**La Jolla Shores Planned District Advisory Board (LJSPDAB)
APPLICANT PROJECT INFORMATION FORM**

- Project Tracking System (PTS) Number/Accela "PRJ" Number and Project Name (only submitted projects to the Development Services Department can be heard as action items):
PRJ-1085883

- Project description:
 - **SITE DEVELOPMENT/COASTAL DEVELOPMENT/NEIGHBORHOOD DEVELOPMENT PLANS**
 - 1 CONSOLIDATED LOT SPLIT INTO 6 INDIVIDUAL LOTS
 - EACH LOT TO CONSIST OF 1 SINGLE FAMILY DWELLING

TENTATIVE MAP NO. 3213966

PROPOSED GRADING PLAN
C-1
LOTS 1-6

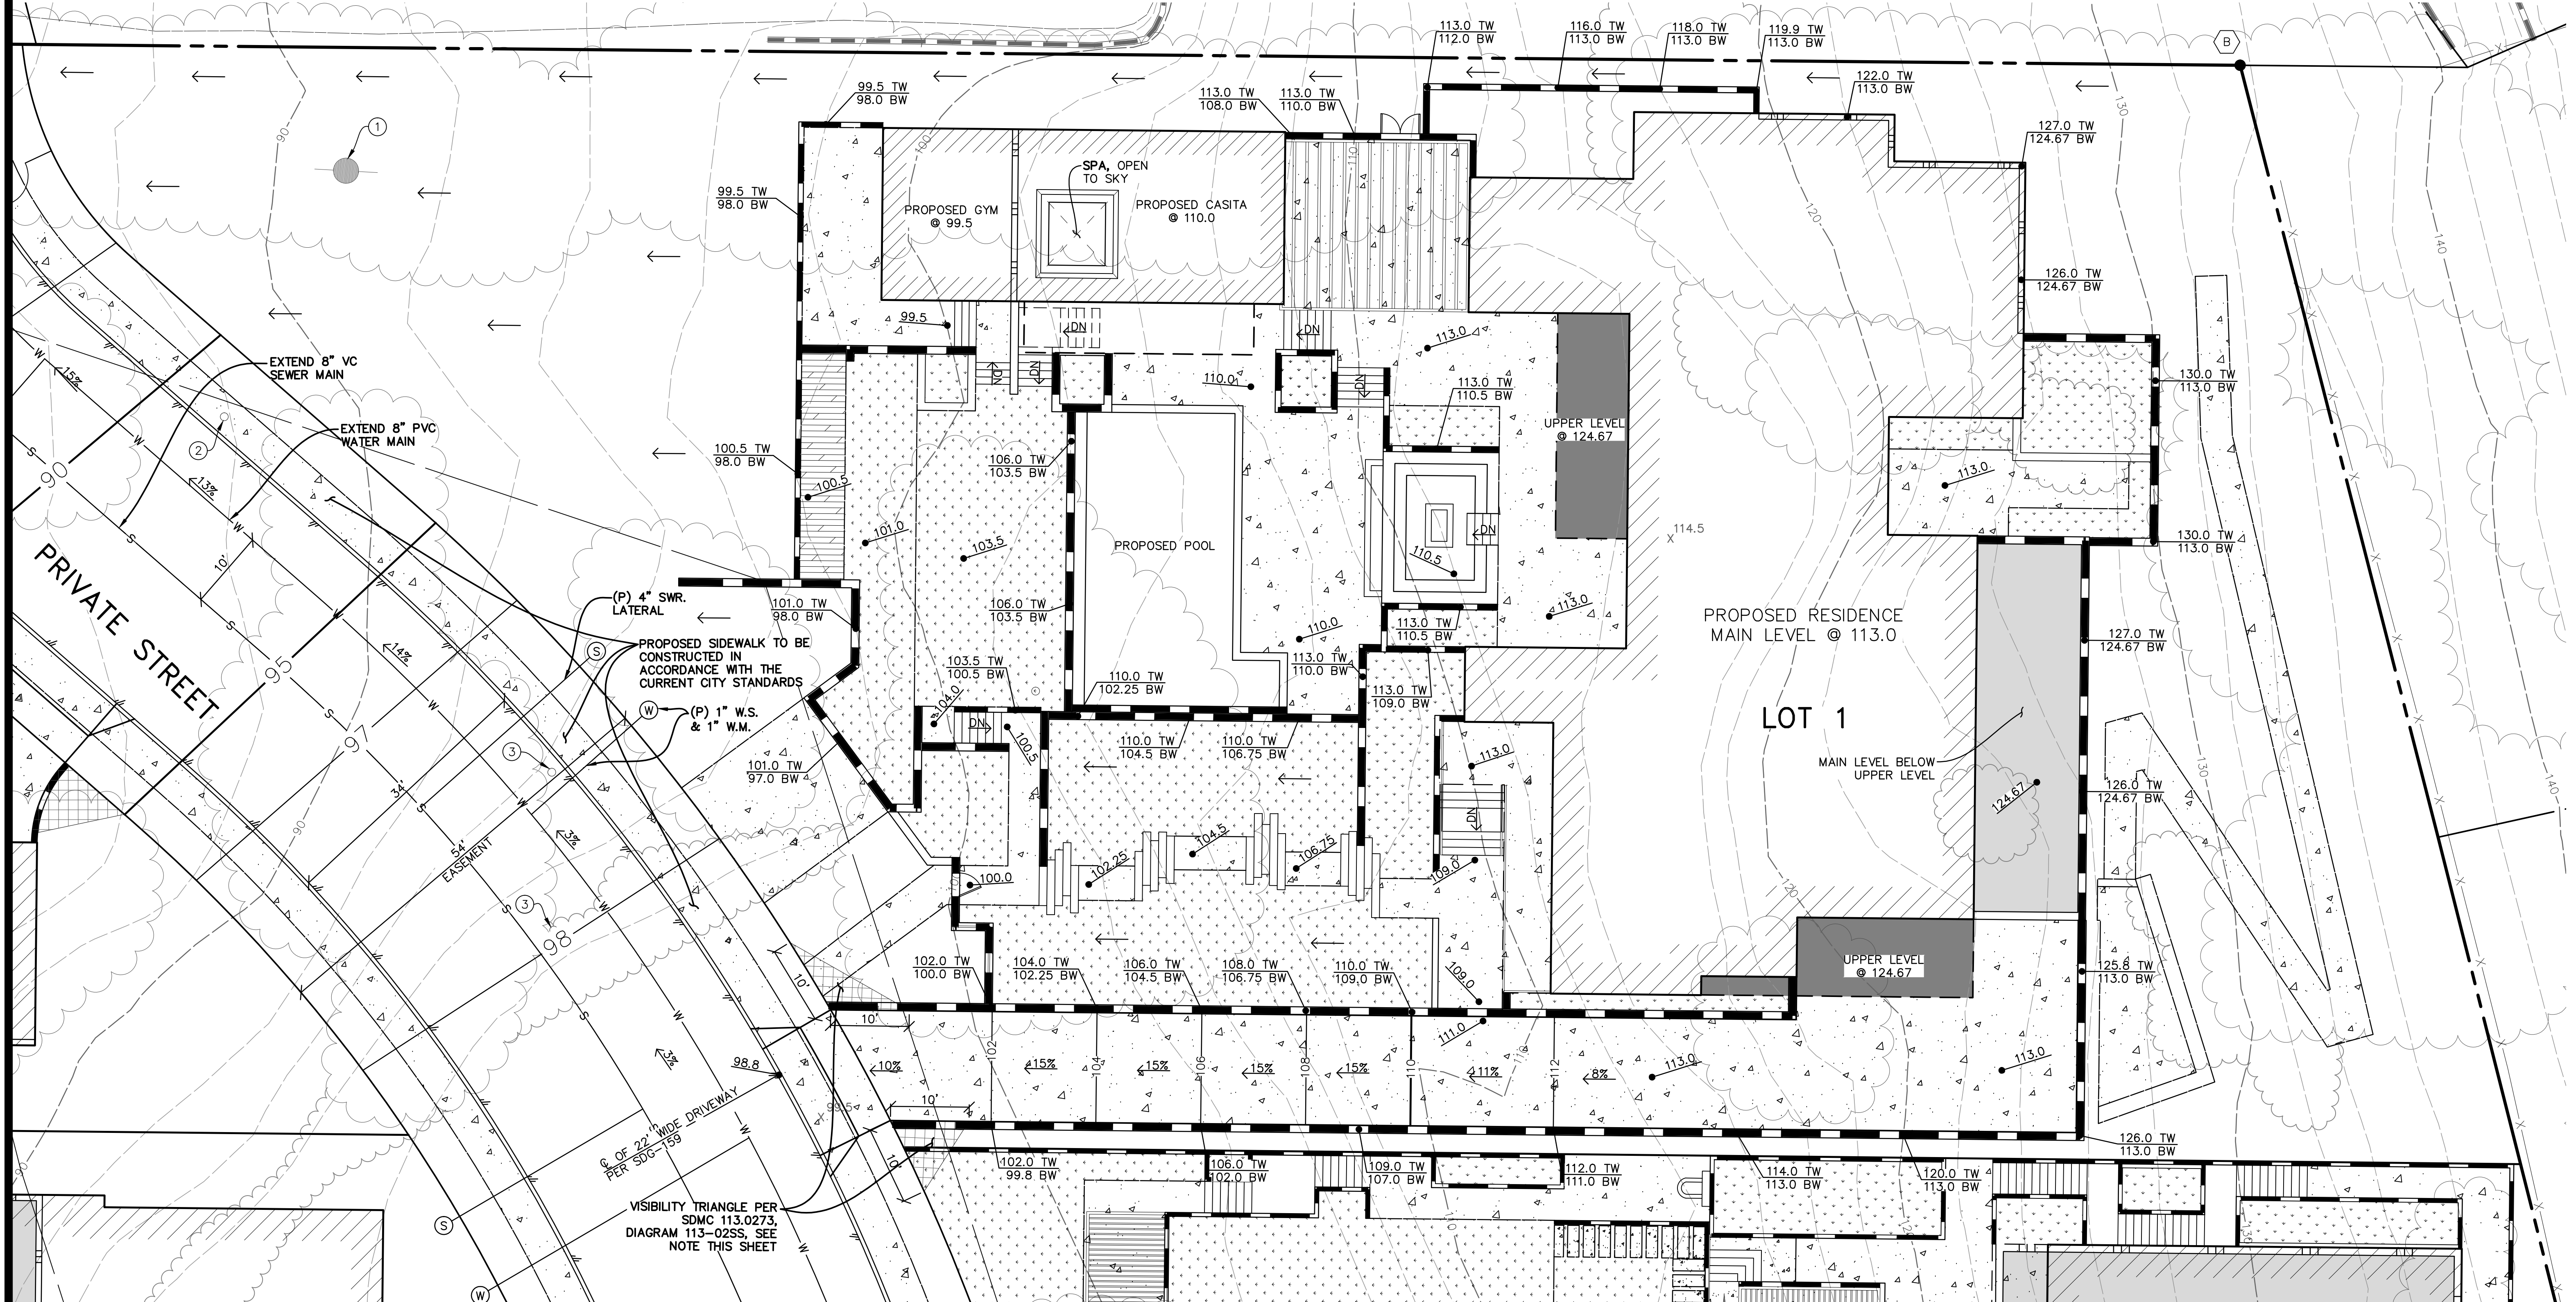
4/23/24- The limits must be clearly shown with a line symbol or labeled "Limits of Grading." Please provide the sheet number of the sheet that satisfies this issue comment. This must be shown on the plans no exceptions. The provided geotechnical report (Plate 1) provides a more expansive area for recommended limits of grading than just the building footprints.

PROPOSED GRADING & DRAINAGE PLAN
C-2
LOT 1

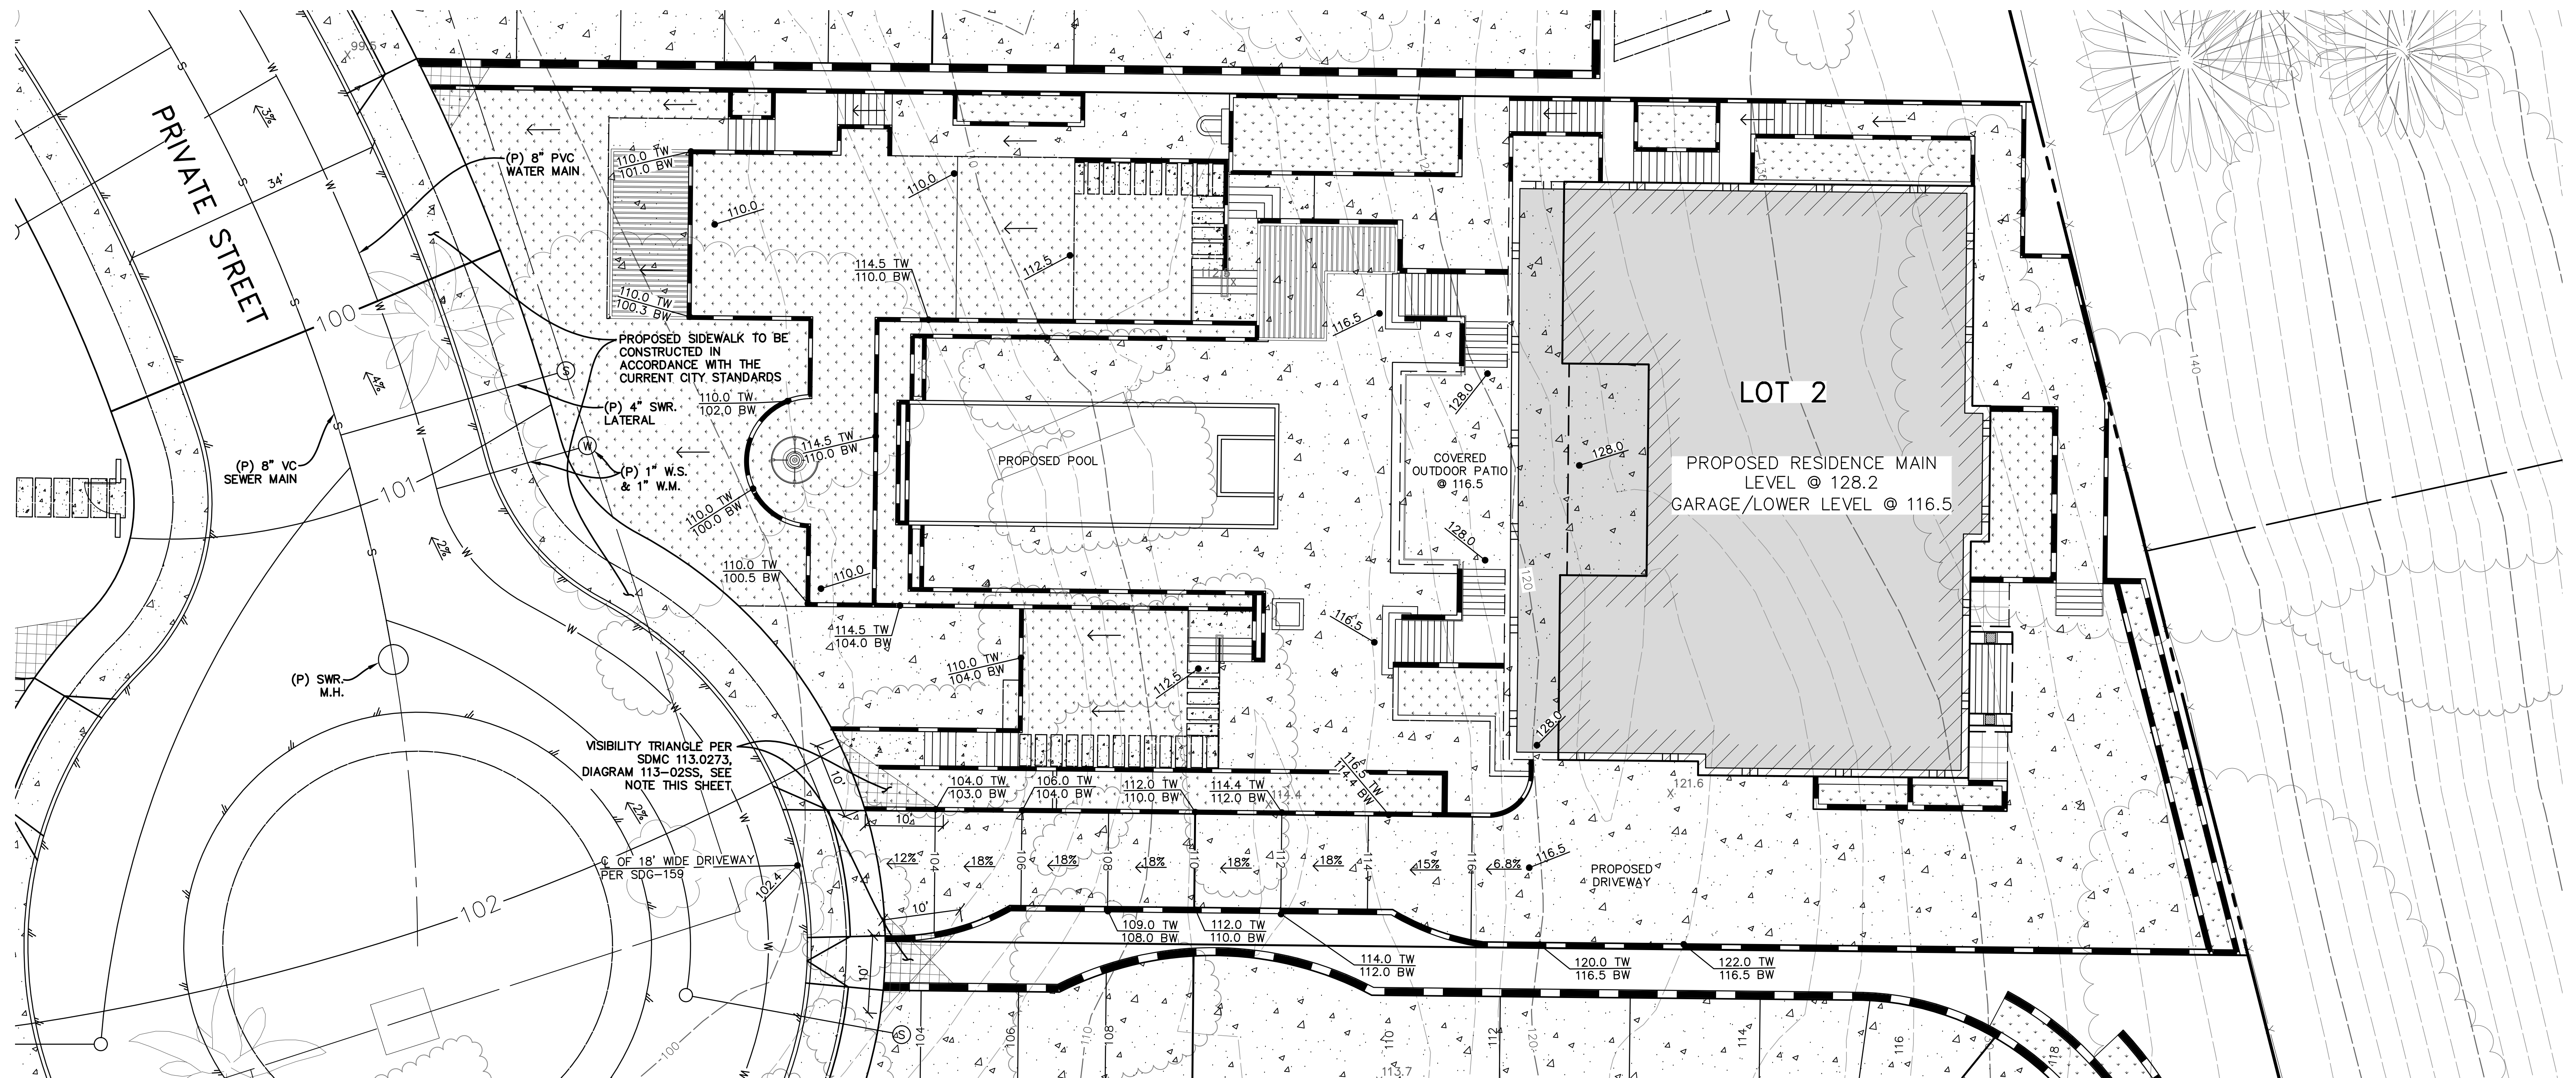
- The transitions for Lot 1 shall not exceed 7.5% grade at the top and bottom of the ramp with a gradient of 15% as shown on Sheet C-2.
 - The transitions for Lot 2 shall not exceed 9% grade at the top and bottom of the ramp with a gradient of 18% as shown on Sheet C-3.
 - The transitions for Lot 3 shall not exceed 8.9% grade at the top and bottom of the ramp with a gradient of 17.8% and shall not exceed 8% grade at the top and bottom of the ramp with a gradient of 16% as shown on Sheet C-4.
- Please revise Sheets C-2, C-3, and C-4 accordingly and show the length of these transitions as 8 feet for the first and last of the driveway ramp. (2nd Request)

1 OVERALL SITE PLAN
SCALE = 1" = 20'-0"

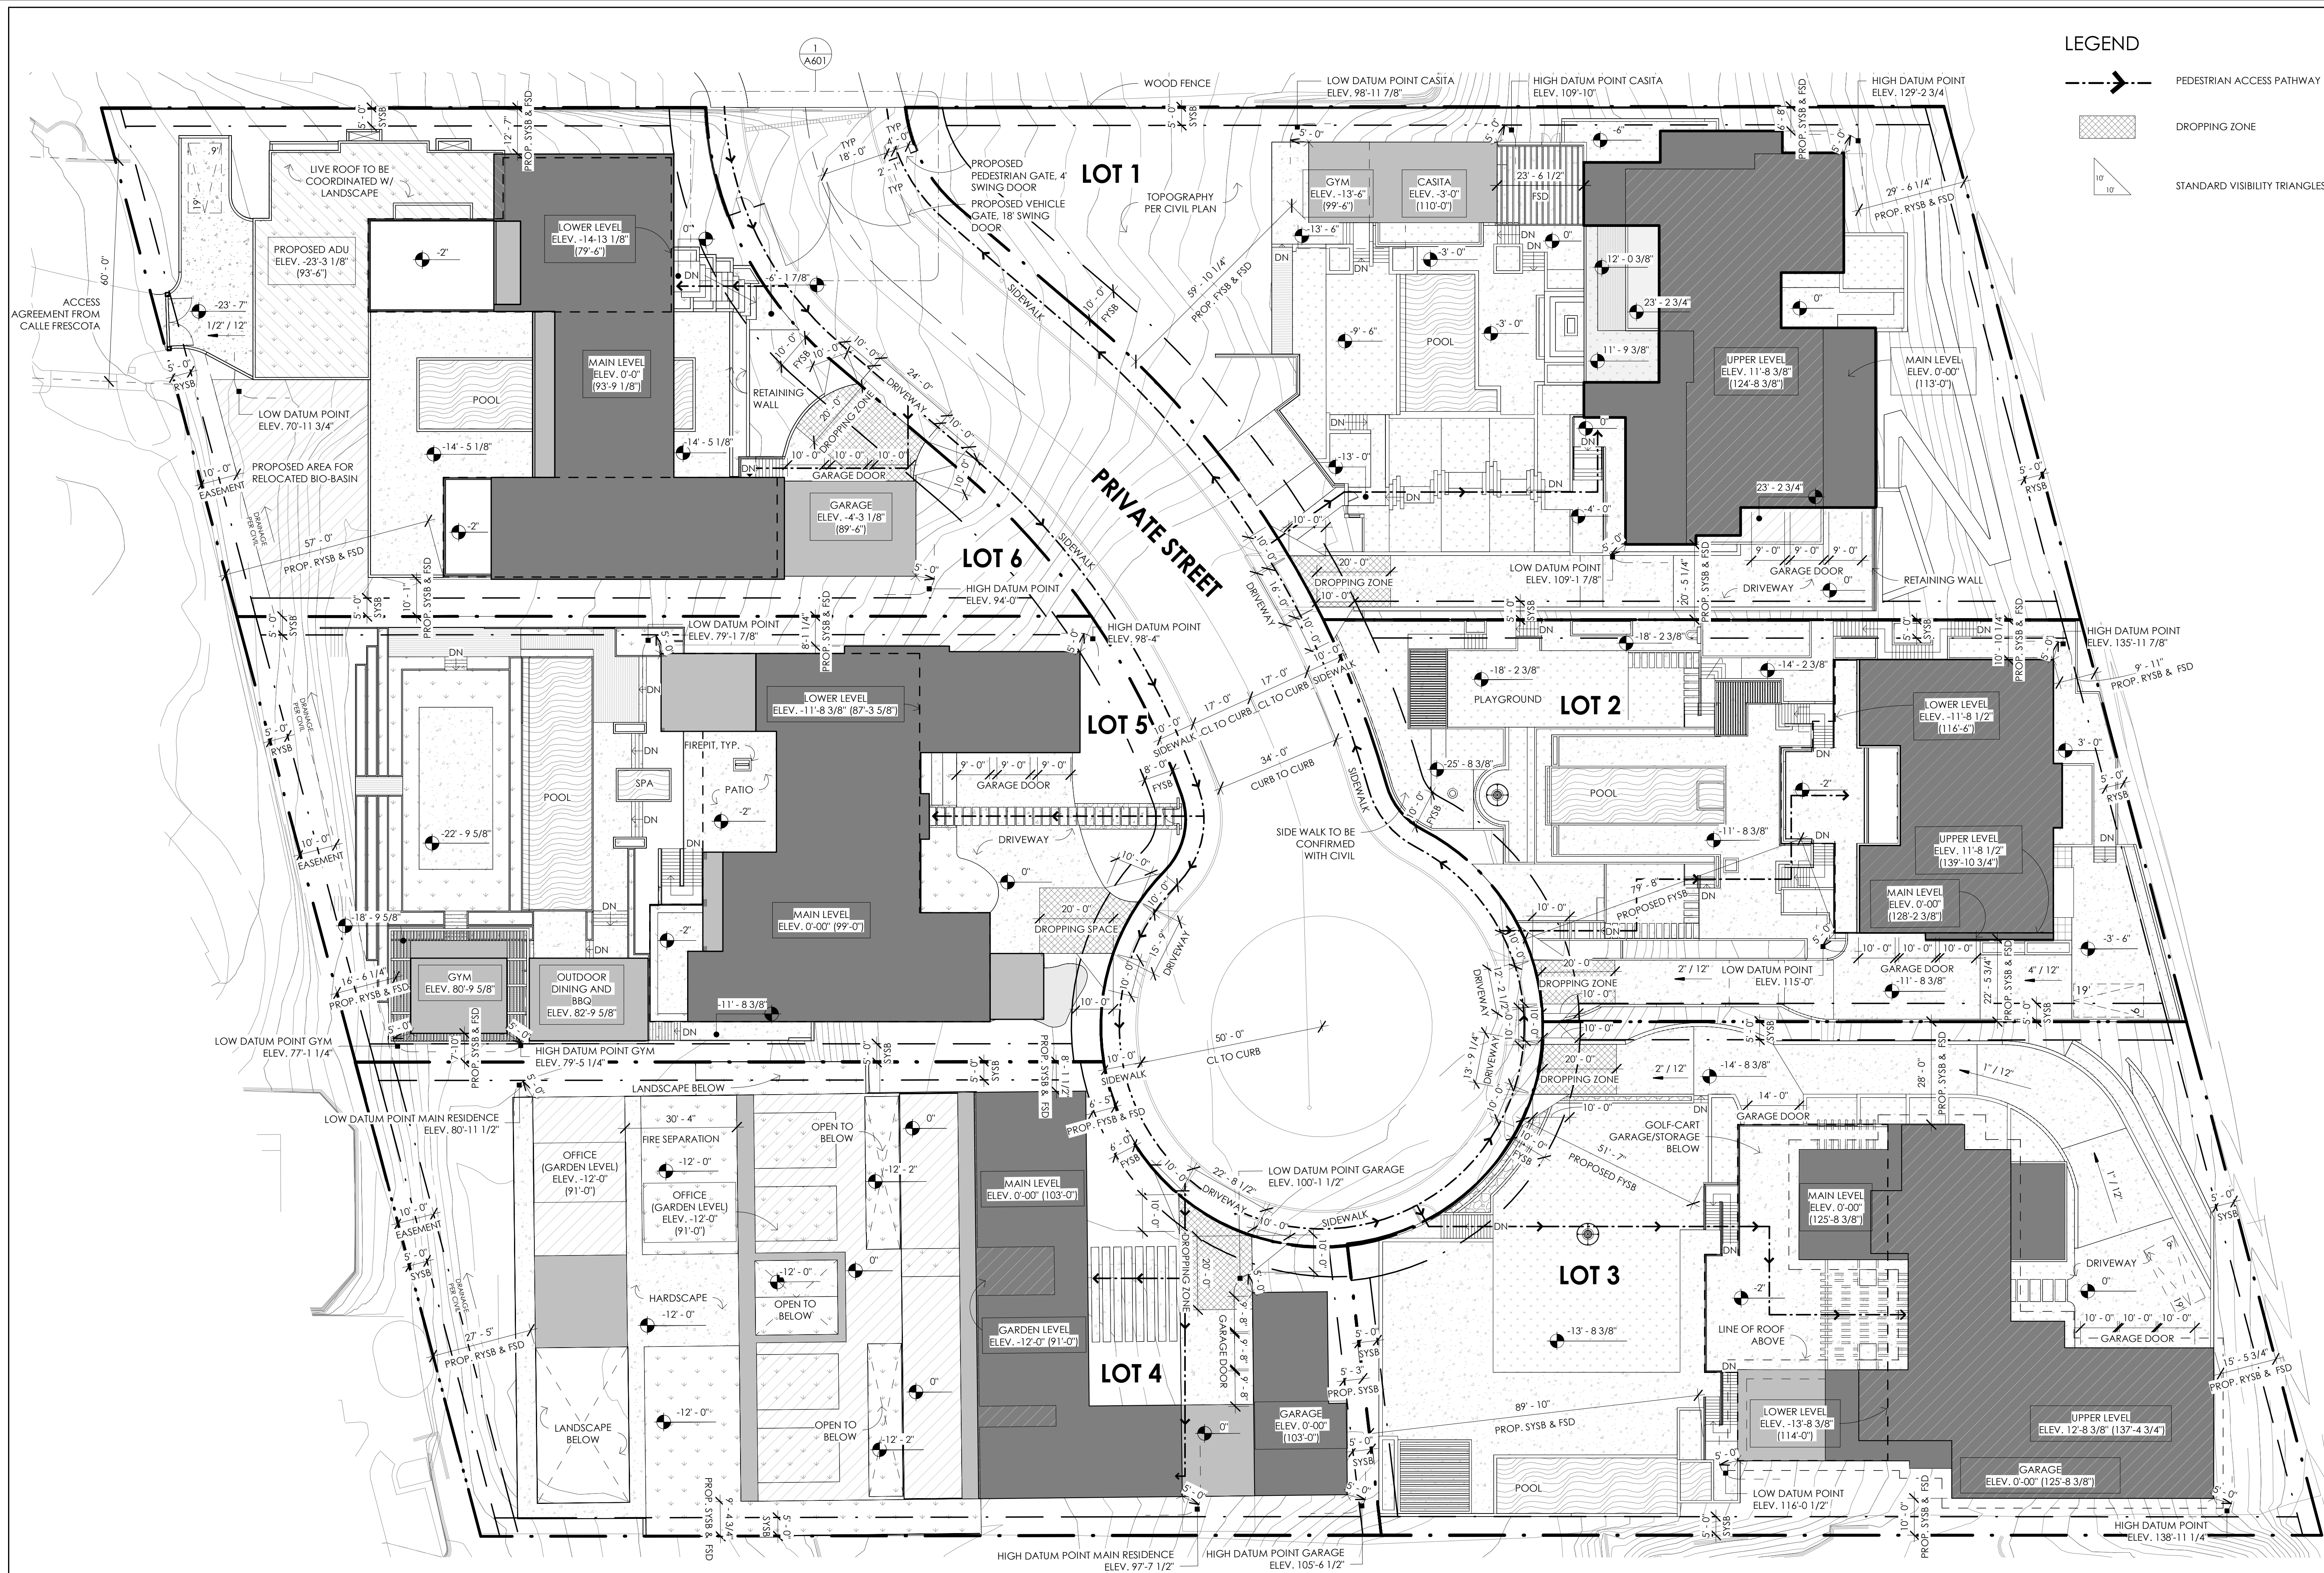
Following up on comments #111 and 210, Sheet A000 has been revised to show pedestrian circulation along the proposed sidewalk on the proposed private street. Please show and label the proposed pedestrian access from the Calle Del Cielo right-of-way to the project site.

Following up on comments #102 and 200, Sheet A000 shows and labels a 20 ft "dropping zone" in each lot. Please demonstrate a minimum 20 ft long area from the back of the sidewalk on the private street to each garage and eliminate the "dropping zone" label on each lot.
